United States Patent and Trademark Office

APPLICATION NO.	FILING DATE	FIRST NAMED INVENTOR	ATTORNEY DOCKET NO.	CONFIRMATION NO.	
10/562,231	12/21/2005	Pascal Benoit	PF030105	5461	
7590 08/10/2006			EXAM	EXAMINER	
Joseph S Tripoli			CHAPEL,	CHAPEL, DEREK S	
Thomson Licens	sing Inc				
Patent Operations			ART UNIT	PAPER NUMBER	
PO Box 5312			2872	2872	
Princeton, NJ 08543-5312			DATE MAILED: 08/10/2006

Application No.	Applicant(s)				
	10/562,231	BENOIT, PASCAL				
Office Action Summary	Examiner	Art Unit				
	Derek S. Chapel	2872				
The MAILING DATE of this communication appears on the cover sheet with the correspondence address Period for Reply						
A SHORTENED STATUTORY PERIOD FOR REPLY IS SET TO EXPIRE 3 MONTH(S) OR THIRTY (30) DAYS, WHICHEVER IS LONGER, FROM THE MAILING DATE OF THIS COMMUNICATION. - Extensions of time may be available under the provisions of 37 CFR 1.136(a). In no event, however, may a reply be timely filed after SIX (6) MONTHS from the mailing date of this communication. - If NO period for reply is specified above, the maximum statutory period will apply and will expire SIX (6) MONTHS from the mailing date of this communication. - Failure to reply within the

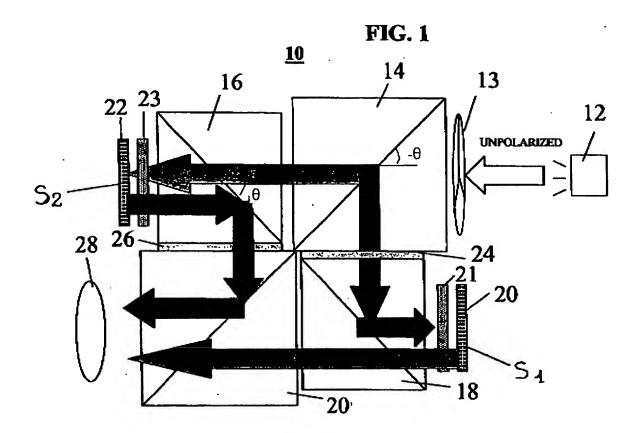
- 16. Claims 1-2, 3/2, 3/1, 4/3/2, 4/3/1, 12-13, 14/13, 14/12, 15/14/13, 15/14/12 and 16-28 are rejected under 35 U.S.C. 102(a) as being anticipated by O'Donnell, European Patent Number EP 1337117 A1, of record (hereafter O'Donnell).
- 17. As to claim 1, O'Donnell teaches an illumination system that generates a light beam of variable color along an illumination axis (See Fig. 1 and Paragraph [0013]);

a second polarization splitter (See Fig. 1, Element 14) adapted to transmit the said polarization of the light beam of variable color in a third direction towards the first polarization splitter (See Fig. 1 and the dark arrow leaving polarization splitter 14 and heading into polarization splitter 16); modulated beam being polarized (See Fig. 1 and Paragraph [0015]).

19. As to claims 3/2 and 3/1, O'Donnell teaches the combinations of claims 1 and 2, in which the splitting surface of the first polarization splitter makes with the light beam an angle having a defined value in a first plane containing the light beam and in which the splitting surface of the second polarization splitter makes with the light beam an angle having an opposite value to the defined value in a second plane containing the light beam and parallel to the first plane (See specifically θ , $-\theta$ in Fig. 1 below as edited by the examiner).
